ECE/TRANS/WP.29/2006/107  
14 July 2006

**PROPOSAL FOR SUPPLEMENT 1 TO THE 02 SERIES OF AMENDMENTS TO  
REGULATION No. 107**

(M<sub>2</sub> and M<sub>3</sub> vehicles)

Submitted by the Working Party on General Safety Provisions (GRSG)

"Figure 1

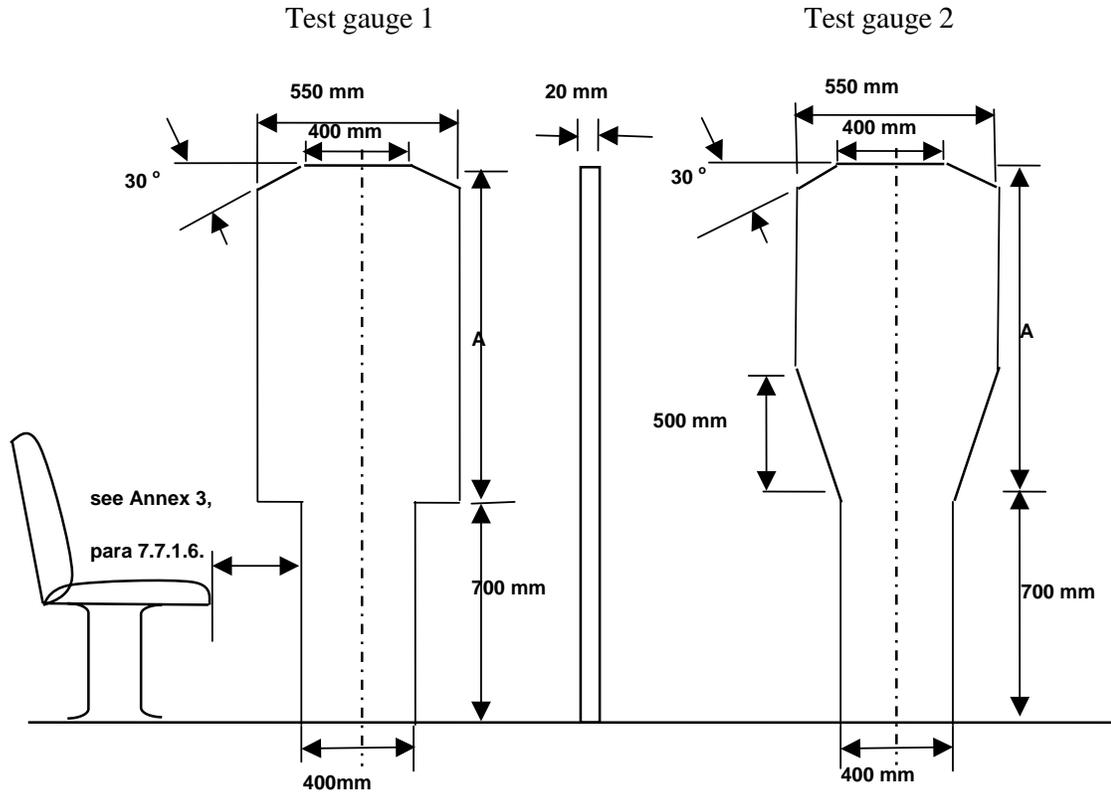
Figure 1, amend to read:

ACCESS TO SERVICE DOORS

Vehicle class	Height of the upper panel (mm) (Dimension "A" figure 1)	
	Test gauge 1	Test gauge 2
Class A	950 */	950
Class B	700 */	950
Class I	1,100	1,100
Class II	950	1,100
Class III	850	1,100

\*/ For vehicles of Class A or B, the lower panel may be displaced horizontally relative to the upper panel provided that it is in the same direction."

"Figure 11b

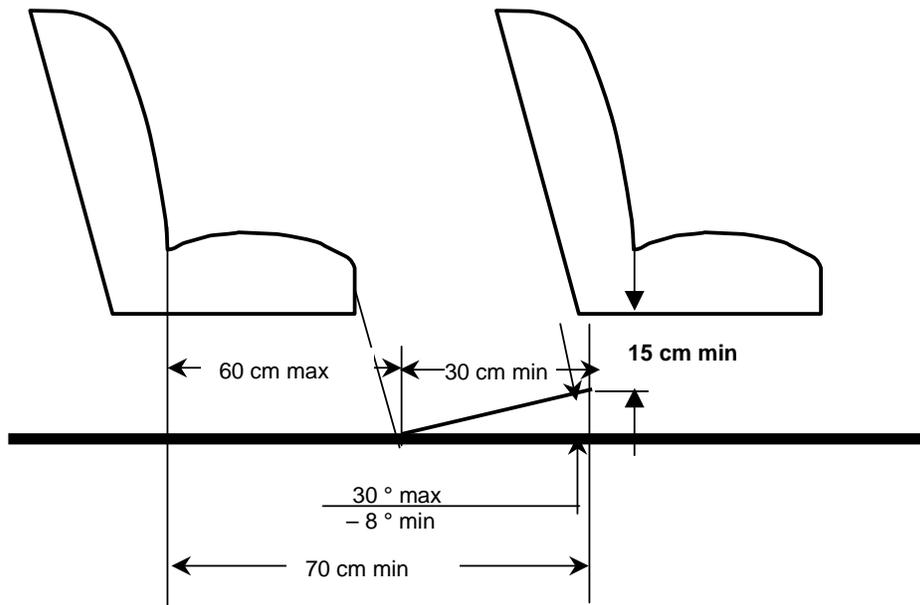
Insert a new Figure 11b, to read:

SPACE FOR FEET OF SEATED PASSENGERS BEHIND A SEAT OR AT A SEAT FACING  
THE GANGWAY

"7.7.8.5.2. For a seat behind a seat and/or a seat facing the gangway, a minimum clear foot space of at least 300 mm depth and a width according to paragraph 7.7.8.1.1., shall be provided as shown in Annex 4, figure 11b. The local presence in this space of seat legs, passenger footrests and of intrusions as provided by paragraph 7.7.8.6. shall be permitted provided that adequate space remains for the passengers' feet. This foot space may partly be situated in and/or above the gangway but shall not create any obstruction when measuring the minimum gangway-width in accordance with paragraph 7.7.5. In the case of seats alongside the driver's seat in vehicles of Class A or B, intrusion of the seat belts and seat belt anchorages shall be allowed."

"Figure 20

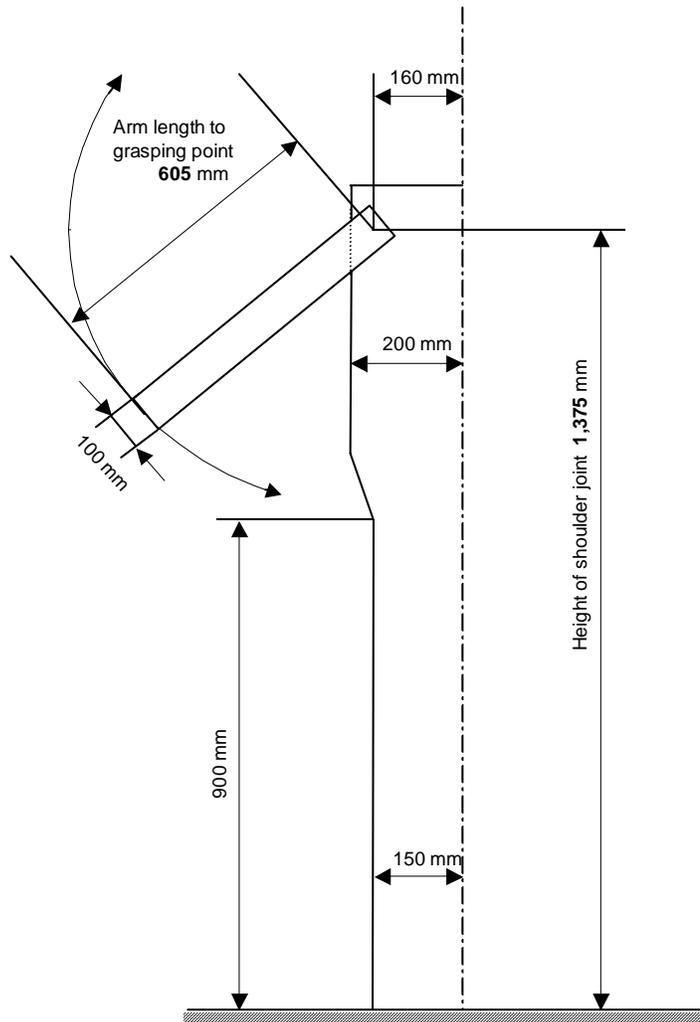
Figure 20, amend to read:

TESTING DEVICE FOR SITING OF HANDHOLDS

Thickness: 20 mm."

Figure 23 A

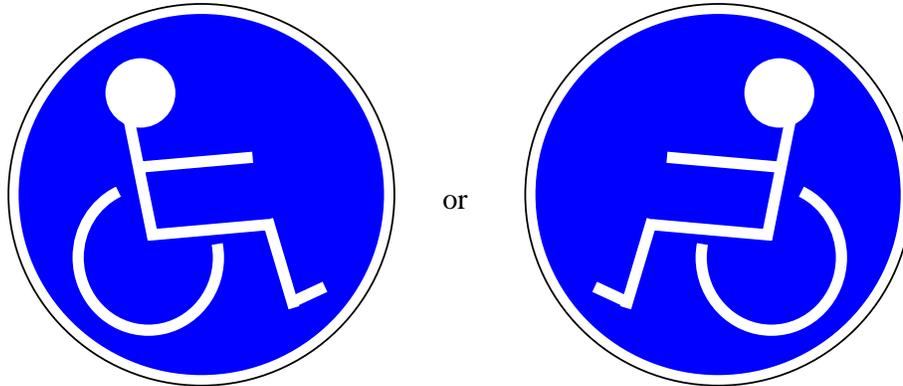
Figure 23, amend to read:

Pictogram for wheelchair users

Colour: blue basis with white symbol  
Size: at least 130 mm diameter

"Figure 27

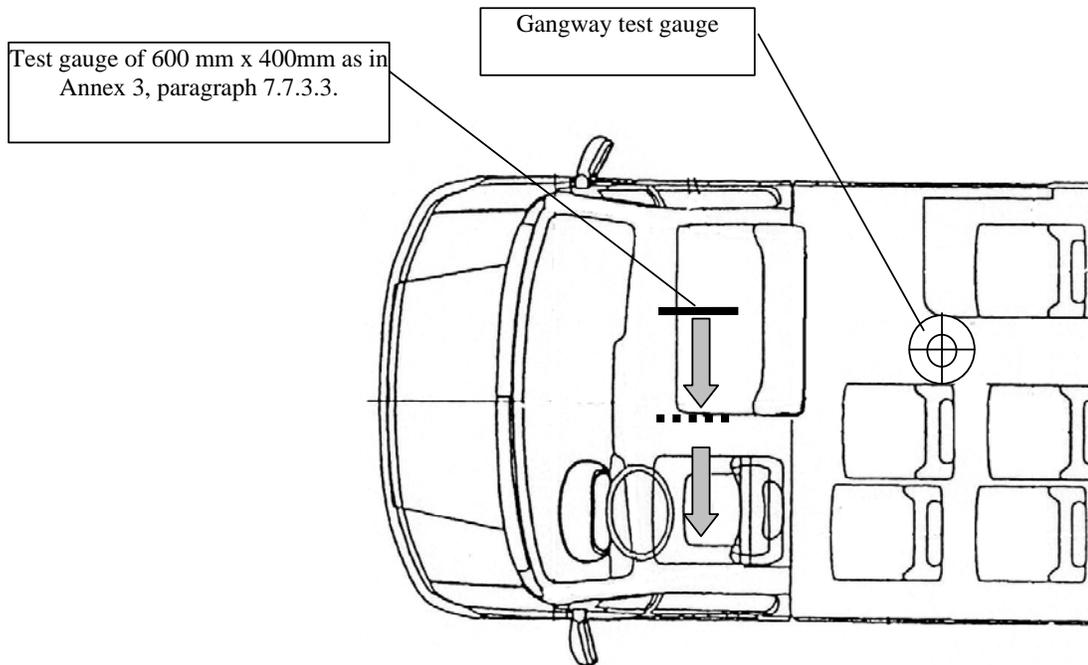
Insert new Figures 27 and 28, to read:

ACCESS TO DRIVER'S DOOR

The driver's door shall be accepted as the emergency door for the occupants of those seats, provided that it is possible to move a test gauge from the occupants' seats to the exterior of the vehicle through the driver's door (see Annex 4, figure 27).

Verification of the access to the driver's door shall be subject to the requirements of paragraph 7.7.3.2., by using the test gauge having a dimension of 600 x 400 mm, as described in paragraph 7.7.3.3.

Figure 28

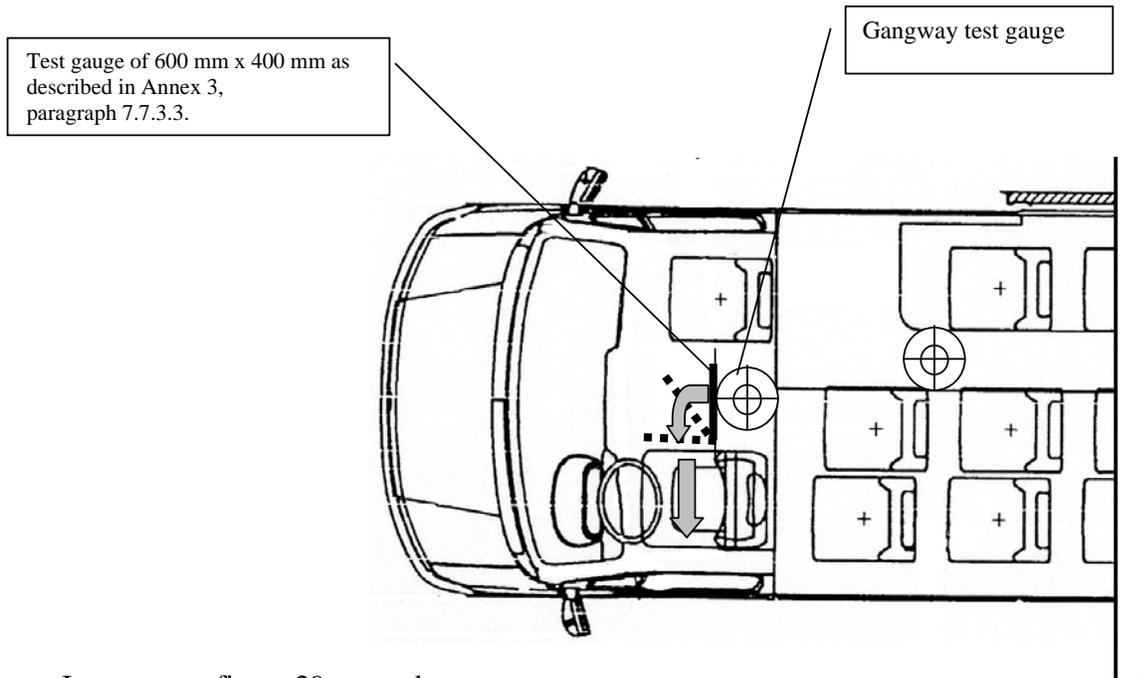
ACCESS TO DRIVER'S DOOR

"7.6.1.9.3. the space reserved for the driver's seat shall communicate with the main passengers' compartment through an appropriate passage; such requirement shall be deemed to be fulfilled if the test gauge described in paragraph 7.7.5.1. can move unobstructed from the gangway, until the front end of the gauge reaches the vertical plane tangential to the foremost point of the driver's seat back (this seat being situated in its rearmost longitudinal position) and, from this plane, the panel described in paragraph 7.6.1.7.2. could be moved to the emergency door in the direction established by such paragraph (see Annex 4, figure 28) with seat and steering wheel adjustment in their mid position."
